Notice of Preparation and Scoping Report

CADIZ VALLEY WATER CONSERVATION, RECOVERY, AND STORAGE PROJECT

Scoping Report

Figure 3. Computed drawdown in three hypothetical observation wells.

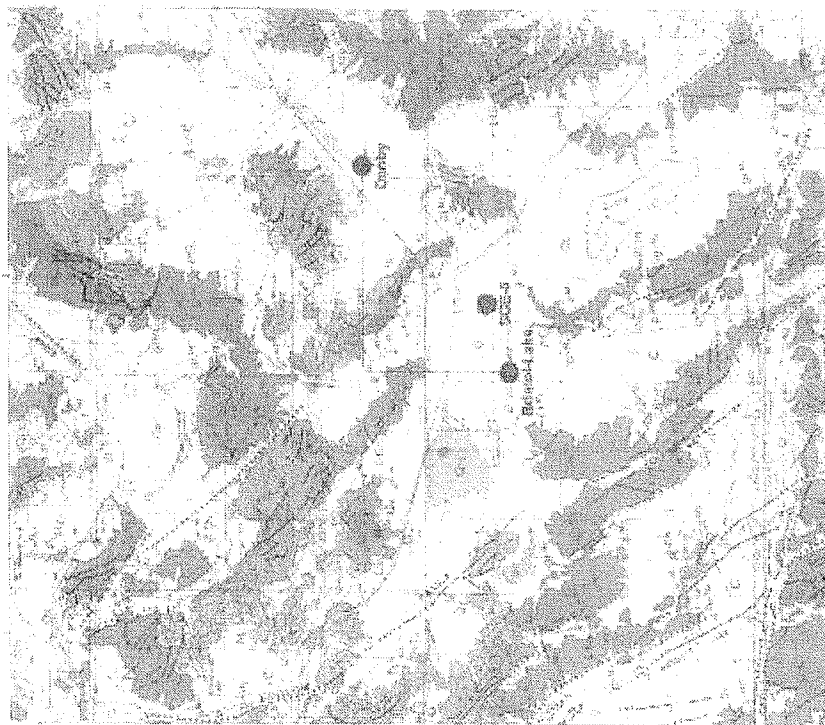
The monitoring situation is a bit clearer beneath Bristol Lake—see Figure 3. There is no decline in the water table beneath the center of the lake out to 20 years. By 30 years the drawdown is approximately 7 feet and by 50 years it is approximately 12 feet. Again this is only the beginning, the drawdown goes to 20 feet in 80 years and remains at 20 feet to 100 years. Even though the project was stopped after year 50, there is no recovery in water levels beneath the lake in 100 years.

Figure 4. Computed plot of TDS in observation well SCE 5.

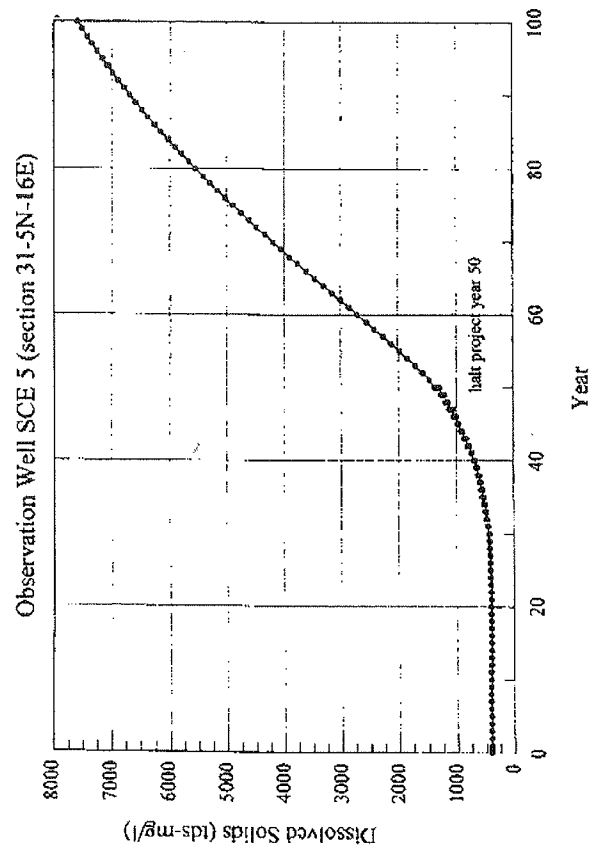
I ran a groundwater transport model to simulate the movement of the brine beneath Bristol Lake. Observation well SCE 5 is situated approximately halfway from the proposed project and Bristol Lake playa—see Figure 2. The total dissolved solids, as observed in this observation well, are plotted in Figure 4. Notice that the dissolved solids start to increase slightly in year 30. By year 45 it increases to 1,000 milligrams per liter (mg/l); by year 50 the concentration is 1,300 mg/l. This water is still useable; but again this is only the beginning. The concentration increases to more than 7,500 mg/l by 100 years, and it is still increasing—again the project was halted 50 years earlier.
